Work Order ID 56963

Item Name: Webbing (Long Basket)

D4029-041 WEBBING (LONG BASKET)

Purchase Order ID PO11512

DETAIL A_{A7-2}**NOTES:**

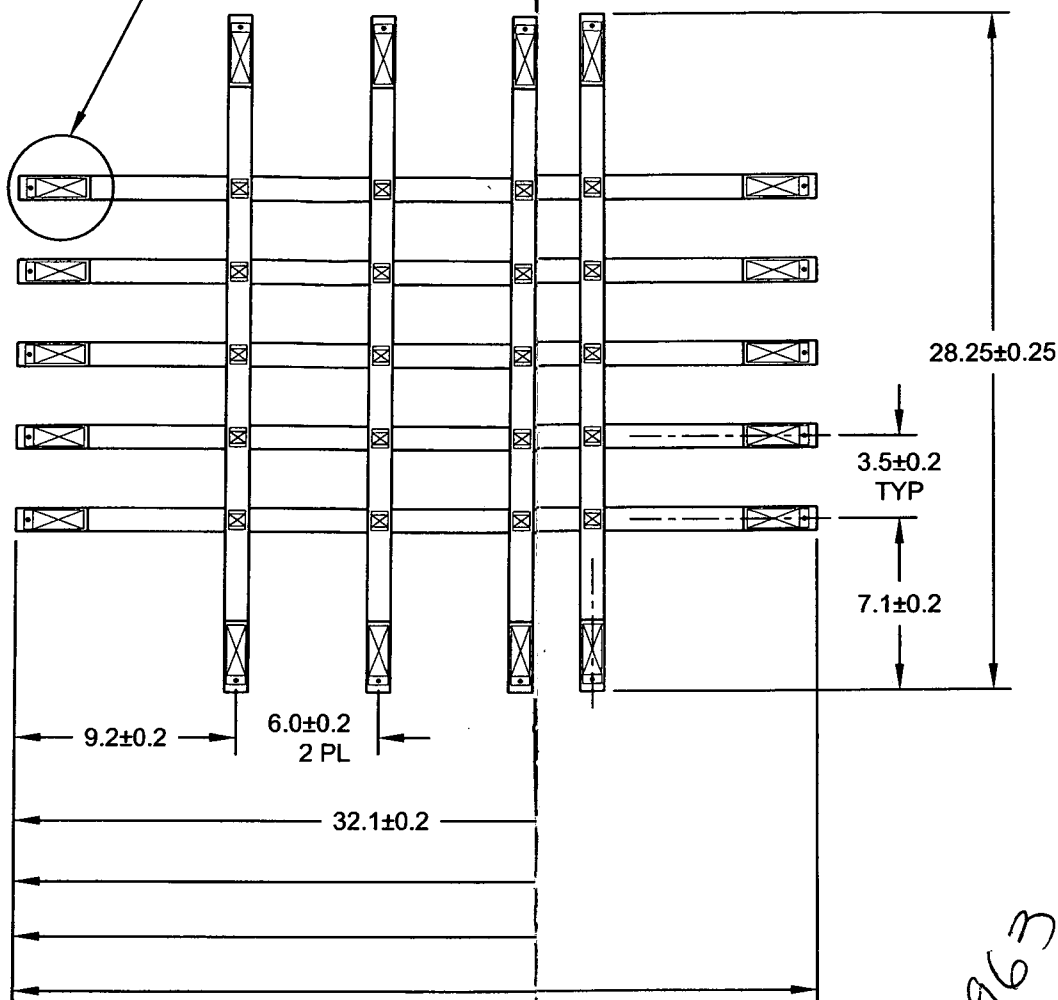
NCR: <u>56963</u>		WORK ORDER NON-CONFORMANCE (NCR)						
DATE	STEP	Description of NC Section A	Corrective Action Section B			Verification Section C	Approval Chief Eng	Approval QC Inspector
			Initial Chief Eng	Action Description Chief Eng	Sign & Date			
10/3/30	100	Found at inspection that the webbing was made to a length of 103.25" about. They should have been made to a length of 101.75"	<u>[Signature]</u> 10/10/08	- Send 101-conforming webs (4x6) Back to AEROTEX to be replaced Supplier? RMA # →		S 10/10/05 (inspected returned)	<u>[Signature]</u> 10/10/08	S 10/03/30
		P.C. were made incorrectly at AEROTEX.	<u>[Signature]</u> 10/10/08	- Aero tech to submit a written copy of the root cause, and corrective action.	CY 01/4/00	Parts.	<u>[Signature]</u> 10/10/08	S 10/03/30

Please send the nets back, we will try our best to make the length shorter by 0.75". But first can you ask the engineer if the 0.75" difference is ok? That way we can save the trouble of sending it back and forth.

****It is very tough for us to get the exact length as the drawing as the net shrinks and varies, when we sew the inside 1" cross boxes****
